STATE OF MAINE  
DEPARTMENT OF TRANSPORTATION  
16 STATE HOUSE STATION  
AUGUSTA, MAINE 04333-0016

January 18, 2013  
Subject: **Yarmouth**  
Federal Project No: IM-1108(600) &  
CM-1749(000)X  
State WIN: 011086.00 & 017490.00  
**Amendment No. 2**

Make the following changes to the Bid Documents:

## *Cedar Rail Fence Detail*

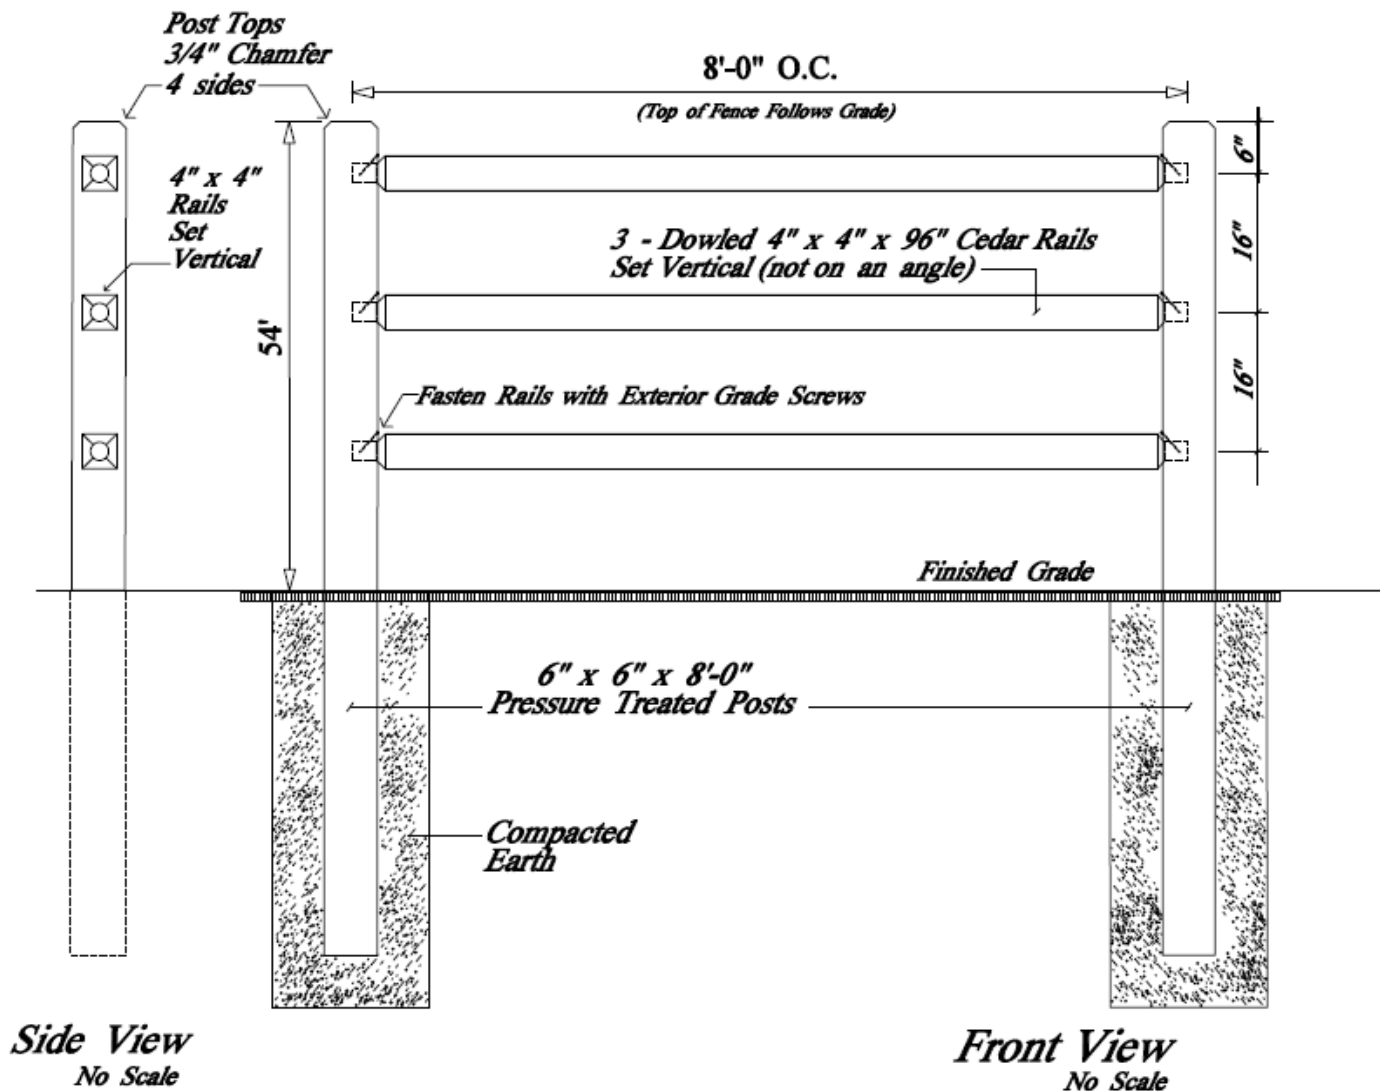
In the Bid Book, after page 121, **ADD** the attached "SPECIAL PROVISION, SECTION 607, FENCES, (Cedar Rail Fence)", 2 pages dated January 8, 2013.

**Question:** Are there any specs/details for items 607.421 and 607.22? We didn’t see any?

**Response:** The Special Provisions have been included in this amendment, please see the above changes.

Description: This work shall consist of furnishing and erecting a 54" high Cedar Rail Fence as shown on the plans and in accordance with these Special Provisions and as directed by the Resident Engineer.

Materials: Posts shall be 6"x 6" Pressure Treated and a minimum of 96" long. Rails shall be 4"x 4" x 96" long northern white cedar and screws shall be exterior grade.

## Double Sided Wood Screening Fence Detail

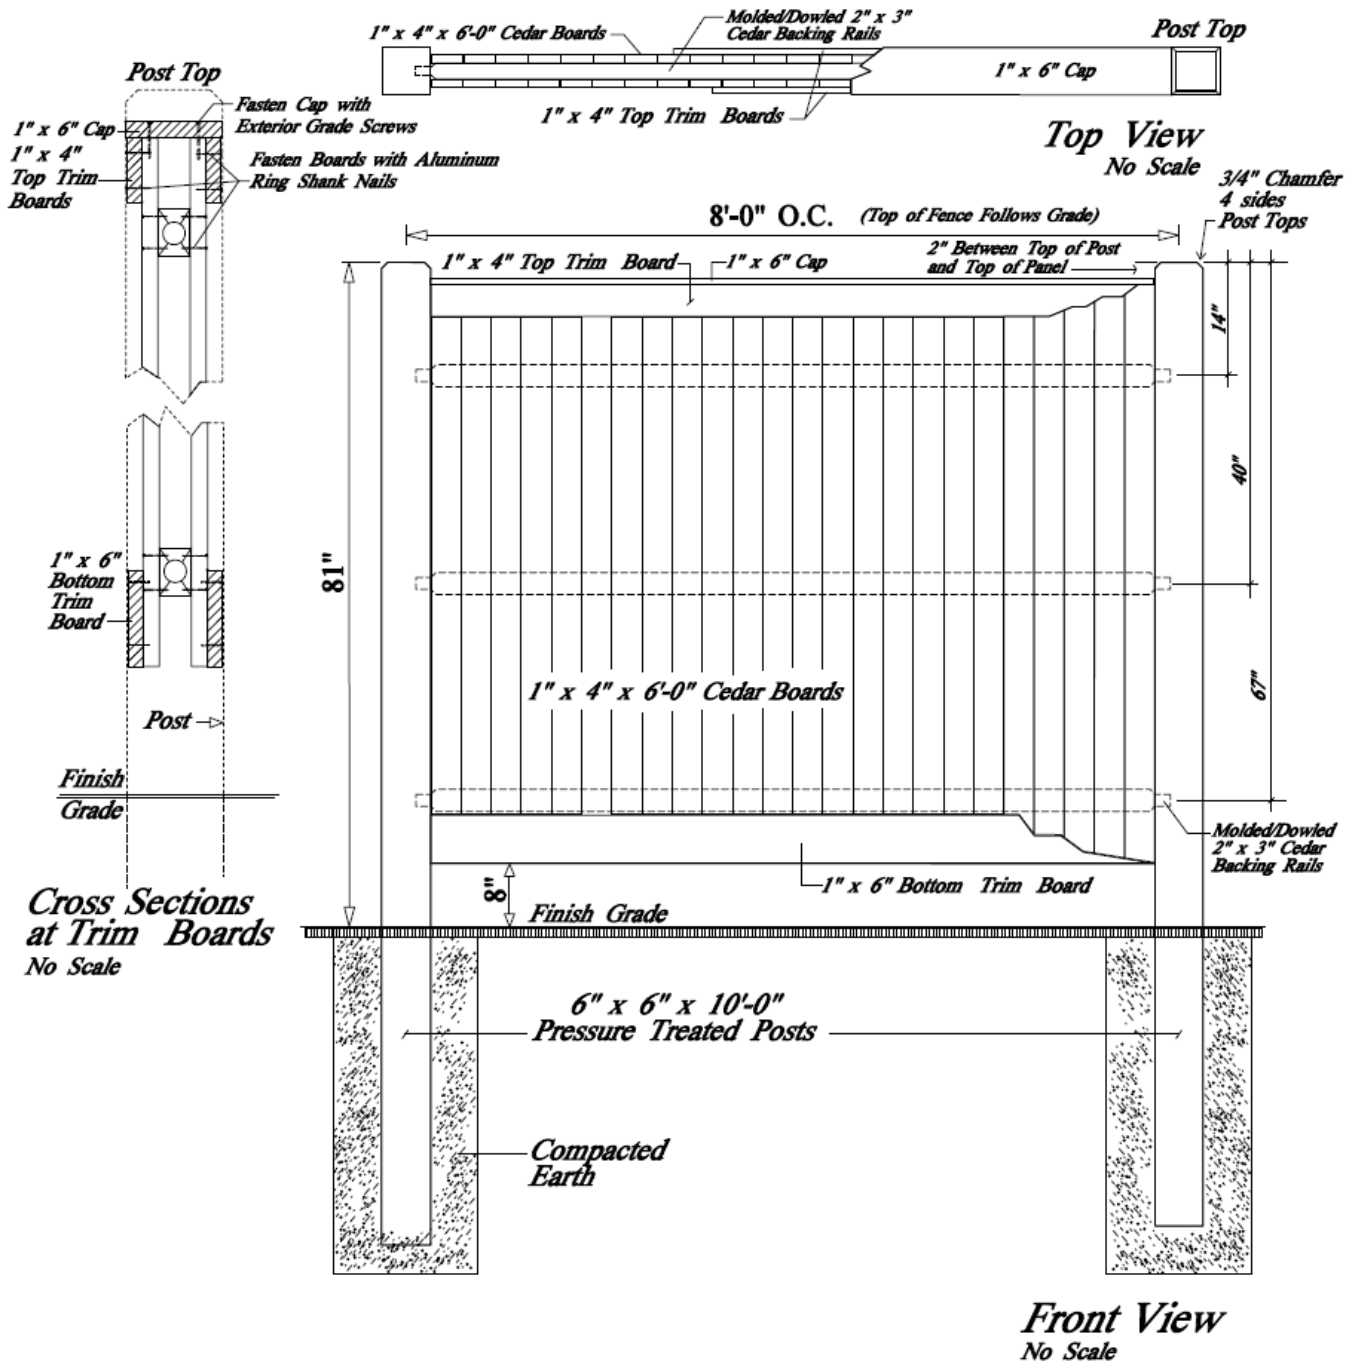
In the Bid Book, before page 122, **ADD** the attached "SPECIAL PROVISION, SECTION 607, FENCES, (Wood Screening Fence)", 2 pages dated January 8, 2013.

Description: This work shall consist of furnishing and erecting a double-sided Wood Screening Fence as shown on the plans and in accordance with these Special Provisions and as directed by the Resident Engineer.

Materials: Posts shall be 6"x 6" Pressure Treated and a minimum of 10' long. Rails, fence boards and trim/cap boards shall be northern white cedar. Nails shall be aluminum ring shank and screws shall be exterior grade.

Yarmouth Park and Ride 11086.00

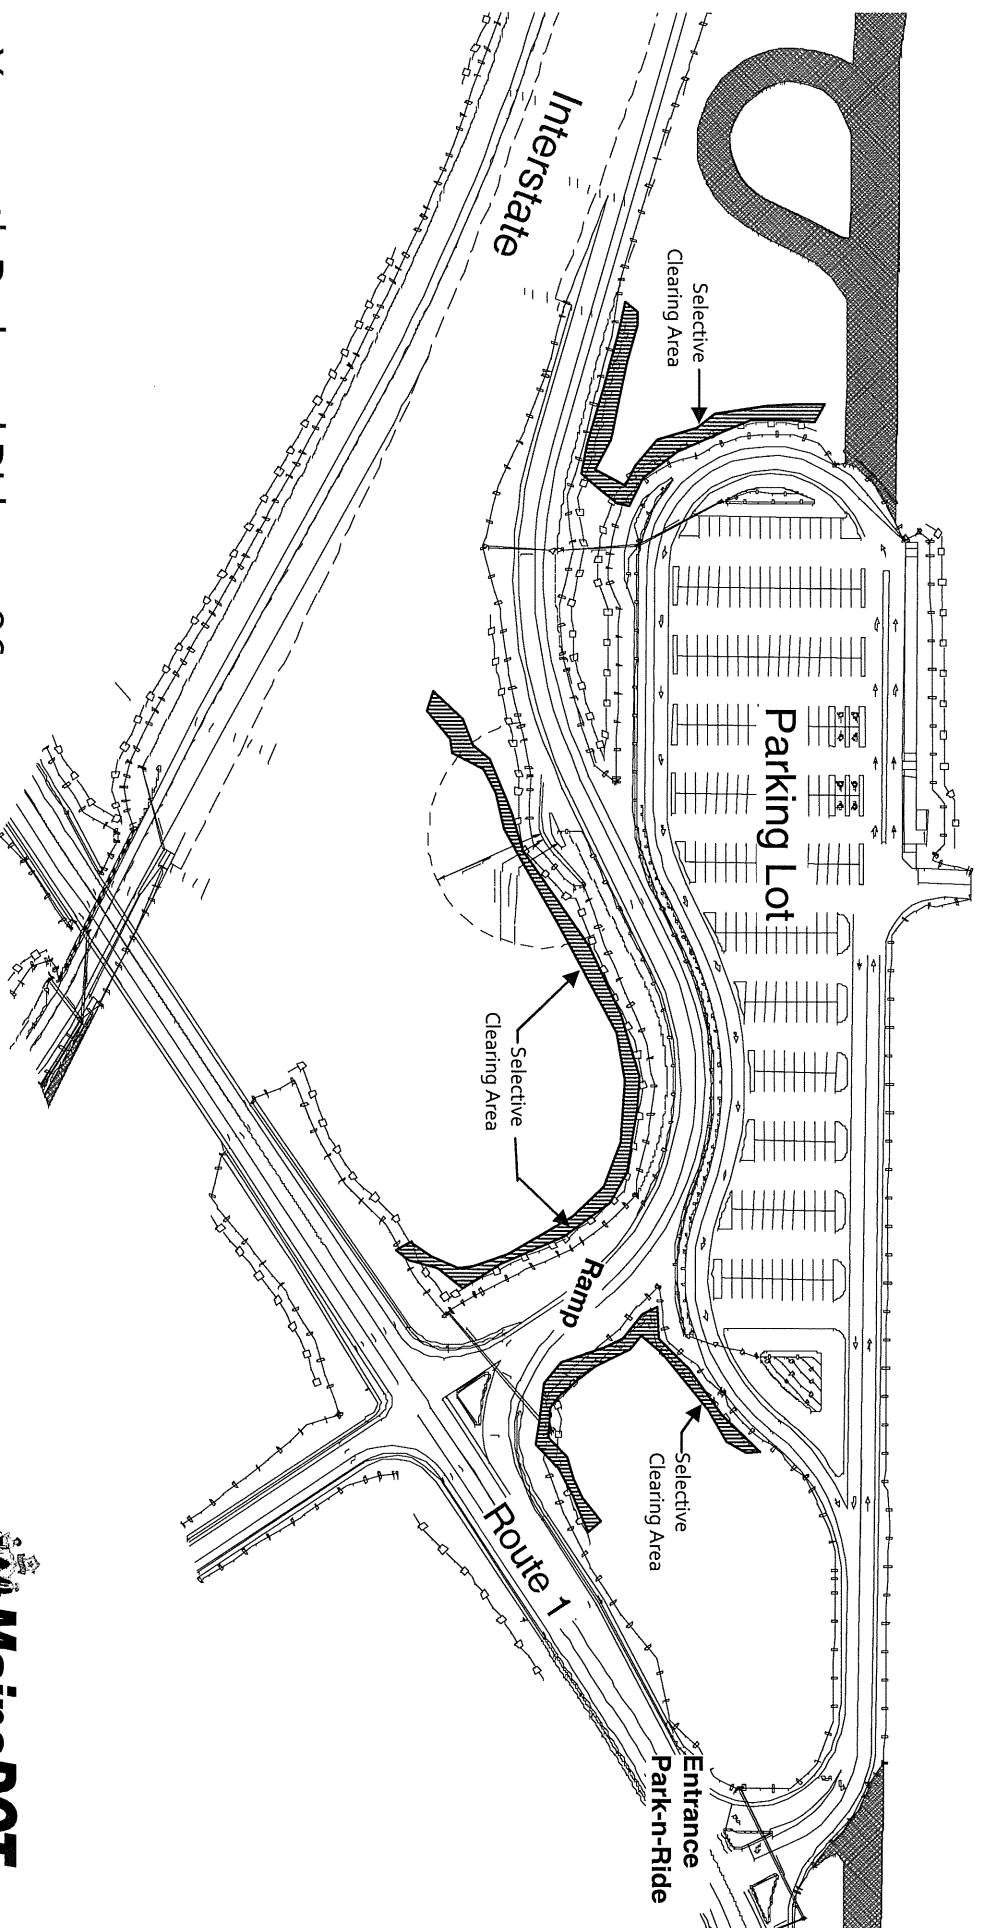
**Question:** I may have missed seeing a label, but can MDOT provide stations for item 201.12, “Selective Clearing and Thinning”?

**Response:** Please see the attached diagram containing locations for Selective Clearing (Item 201.12).

The locations for Selective Clearing (Item 201.12) on the project are indicated in the areas below or as directed by the Resident. Wooded edges will be landscape areas viewed by the public and shall be selectively cleared and pruned in a natural manner under selective clearing specifications.
